Networks NSW - Draft Determination Review

System Capex & Maintenance Prudency Assessment

Document No. 1 | Version No. 1

15 January 2015

Figure 3-1: Combined baseline capex forecast for the NSW DNSPs – strategic risk/expenditure profile highlighted at high-medium / 70-80% and implied risk / expenditure profile with expenditure reduced to \$5.5 b

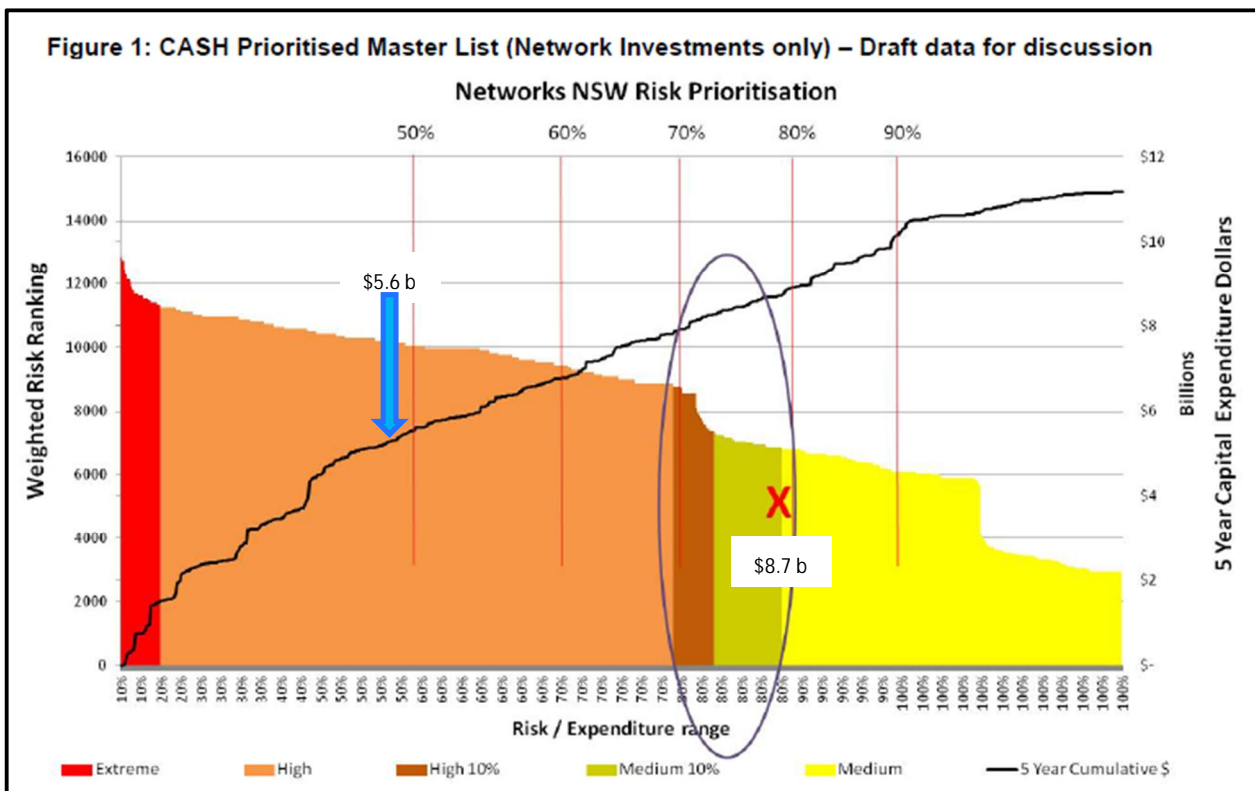
Also indicated in Figure 3-1 is the implied expenditure/risk profile with the combined capex forecast reduced to \$5.55 billion in accordance with the AER’s Draft Determinations. **Jacobs has not observed a robust discussion in Draft Determination documents that gives due consideration to this potential change to the combined risk profile of the NSW DNSPs should the indicated capex reductions be adopted.**

while maintaining a prudent overall risk profile through improving efficiencies. However, the figure below illustrates the magnitude of indicated reduction against the overall risk profile; and Jacobs considers it unlikely that it would be possible for the NSW DNSPs to absorb the indicated expenditure reductions purely through increased efficiency, especially given that the programs for the first year of the 2014-19 period are largely locked in.

Figure 3-7: Ausgrid – Actual capex in 2009-14 compared to 2014-19 capex Forecast

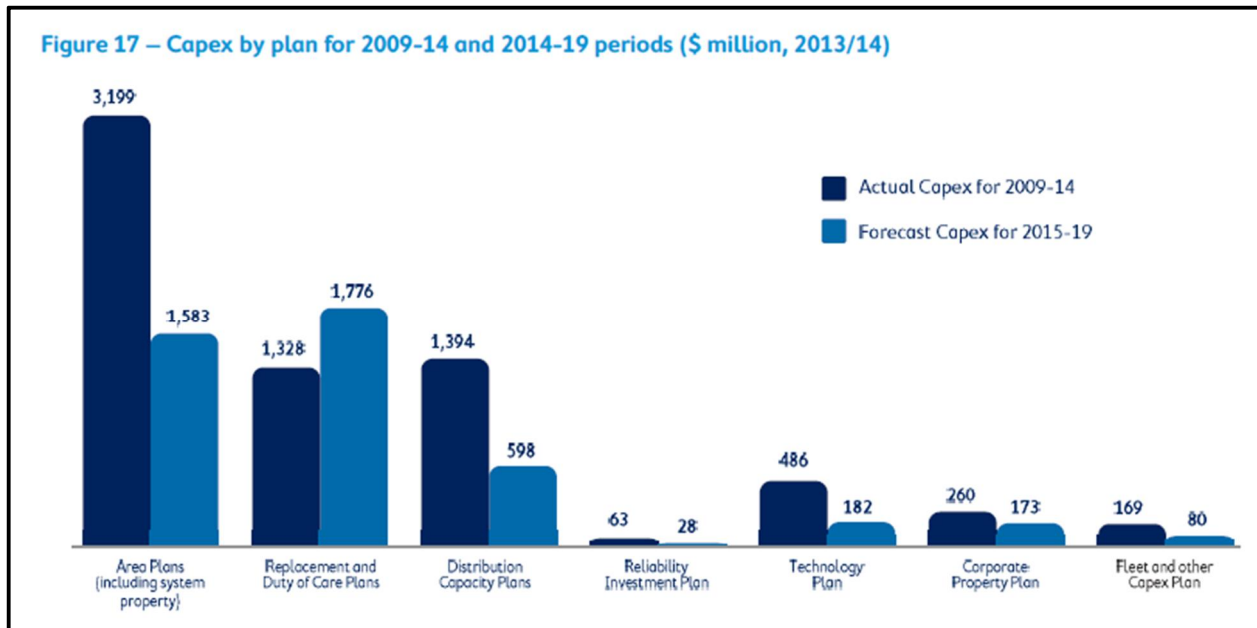
The AER has also expressed concerns regarding Ausgrid’s and Essential Energy’s capacity to deliver their proposed capex programmes after they encountered deliverability issues throughout the 2009-14 period and fell significantly short of delivering on the approved capex programmes. However, Jacobs notes that the proposed capex programmes for the 2014-19 period are significant reductions on the previous period. Importantly, the proposed capex program for the 2014-19 period is significantly reduced from the actual capex works delivered during the 2009-14 period for all NSW DNSPs. Figure 3-7 below illustrates how the proposed 2014-19 capex for Ausgrid is significantly lower than the actual capex delivered in 2009-14.

Figure 3-9: FMECA/RCM output – Essential Energy Cross-arms

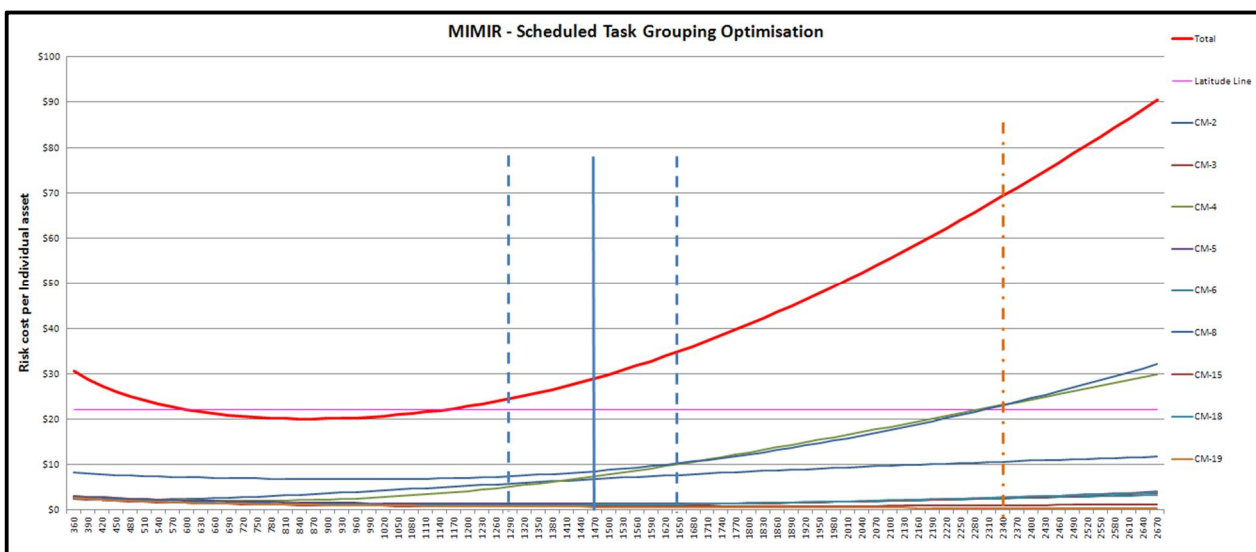
- The schedule delay, represented by the gap between the blue and orange vertical lines, will result in an approximate maintenance increase of 140% for the selected failure modes.

Figure 3-9 clearly demonstrates how the effects of reducing opex in the short term would result in significantly increased costs associated with managing the asset population over the long term.

Figure 4-1: Breakdown of capex at Risk by Primary Driver

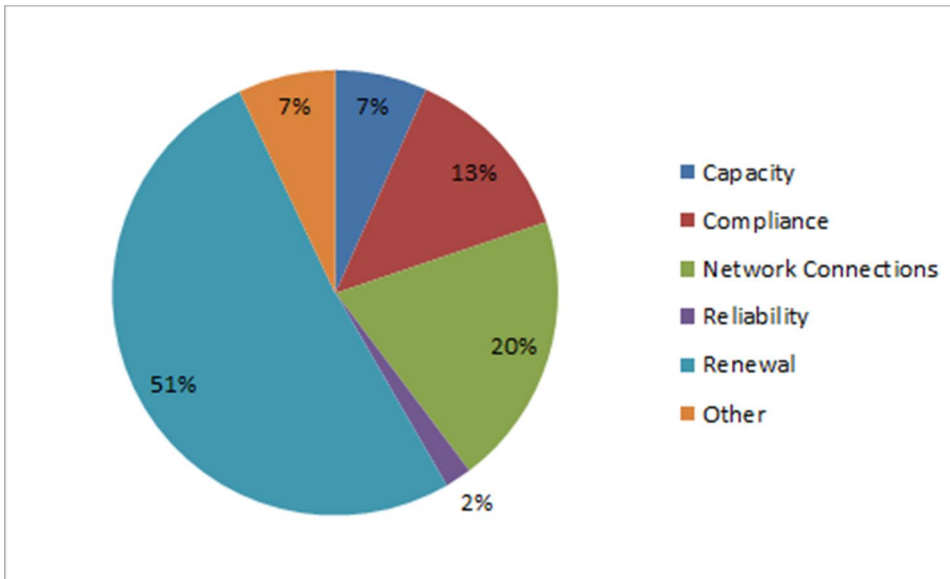
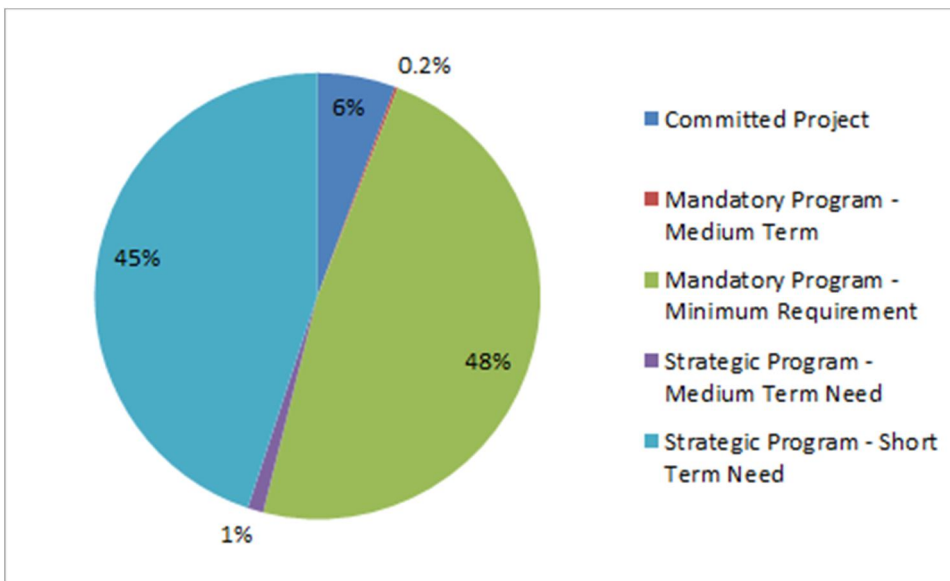
Figure 4-1 and Figure 4-2 below show a breakdown by primary driver and project category for the capex at risk (i.e. those falling below 73% of expenditure sorted based on highest CASH/PIP score). These charts illustrate the difficulty that the NSW DNSPs will have in managing the overall risks associated with providing essential electricity services if the capex reduction indicated in the Draft Determinations are imposed.

They show that the largest proportions of capex at risk are for asset renewals, mandatory programs to meet minimum regulatory requirements, and strategic projects to meet short term needs. This suggests that the networks are likely to:

- Have difficulty meeting their regulatory, customer and other stakeholder obligations.
- Begin showing signs of decreasing reliability and increasing risks to public safety within the 2014-19 regulatory period (as discussed in Section 3.3 with respect to when the impacts on network performance are likely to be evident from reduced opex, repex and augex).

Figure 4-3: Ausgrid Asset Age Profile

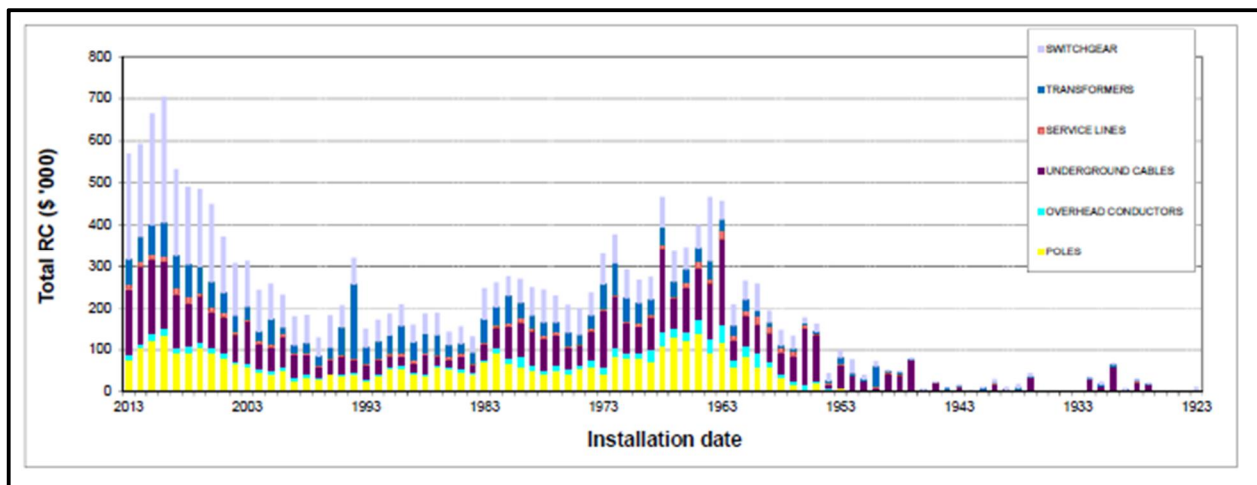
- Ausgrid's asset profile does not follow a normal distribution curve. This suggests that drawing conclusions based on average residual lives may be inappropriate.
- A large number of new assets were commissioned over the last decade. This would have increased the residual lives of the asset population as a whole. However, it does not indicate that the need to replace aging assets has been reduced; especially considering the augex investments over the past decade which are likely to have reduced the average age of the assets without necessarily replacing aging assets.
- There is a significant proportion of aging assets commissioned between 1950 and 1980 which are likely to be deteriorating and require replacement.

Jacobs notes that the Draft Determination makes the statement below. In Jacobs' view this highlights the AER's mistreatment of average residual asset lives, which are not viewed appropriately in conjunction with the age profiles. That is, regardless of the number of aging assets that have been replaced through recent augex, the reduction of the average asset age does not negate the need to replace the assets approaching the end of their serviceable life that were commissioned between 1950 and 1980.

Figure 4-4: Endeavour Energy Asset Age Profile

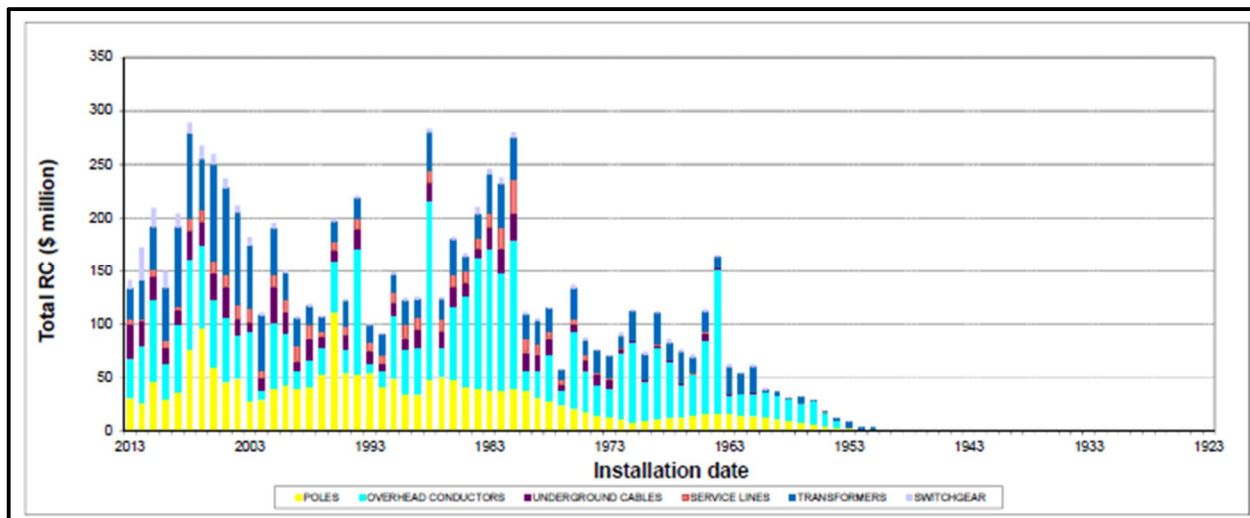
However, as per the discussion with respect to Ausgrid, this would not necessarily result in a steady repex requirement. The age profile of Endeavour Energy's asset population is shown in Figure 4-4 below. It shows that:

- Endeavour Energy's asset profile shows a skewed normal distribution curve, weighted toward relatively newer assets. This suggests that drawing conclusions based on average residual lives may be more reasonable than for Ausgrid.
- The majority of assets were commissioned between 1980 and the present. Although, this indicates that the majority of assets should be in reasonable health, it does not negate the need to replace aging assets.
- Endeavour Energy employ a Weighted Average Remaining Life (WARL) model to make long term forecasts remaining life, which are used in forming their repex programs.

Figure 4-5: Essential Energy Asset Age Profile

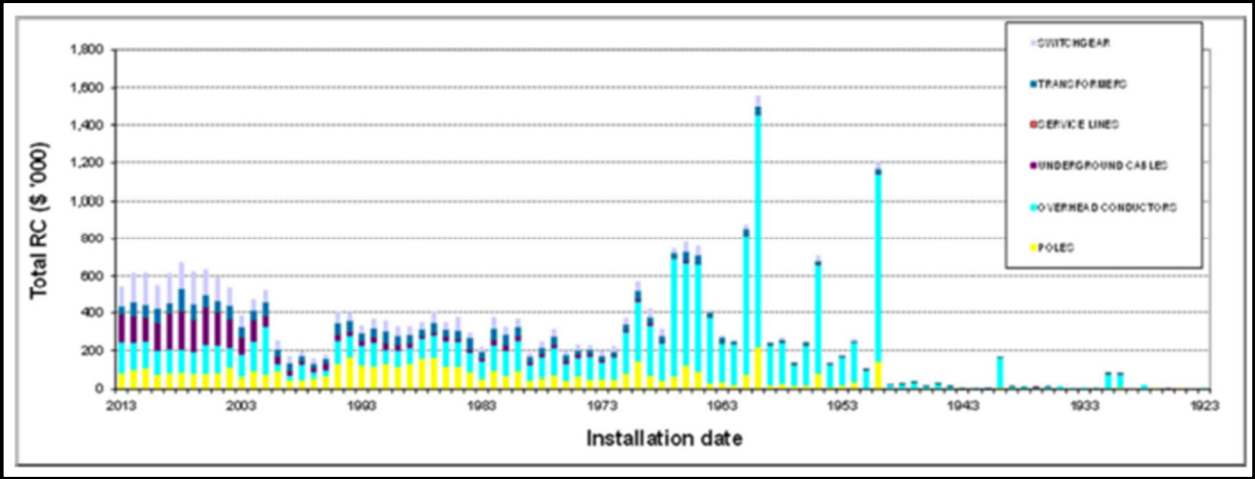
Notwithstanding, as per the discussion with respect to Ausgrid, this would not necessarily translate into repex requirements. The age profile of Essential Energy's asset population is shown in Figure 4-5 below. It shows Essential Energy's asset profile as relatively level, with a large number of aging assets commissioned between 1945 and 1970.

Given this age profile and the declining residual lives over the 2006 to 2013 period, it appears that it would not be unreasonable for some of the assets categories (especially the overhead network shown in light blue in Figure 4-5) to have their residual lives increased above 2006 levels.

Jacobs notes that underground assets above 33kV show a significant increase over 2006 levels. Jacobs expects that in its revised Expenditure Proposal Essential Energy would provide robust

justification that demonstrates the reasons for why the increased estimated residual lives for underground assets 33kV and above are warranted.
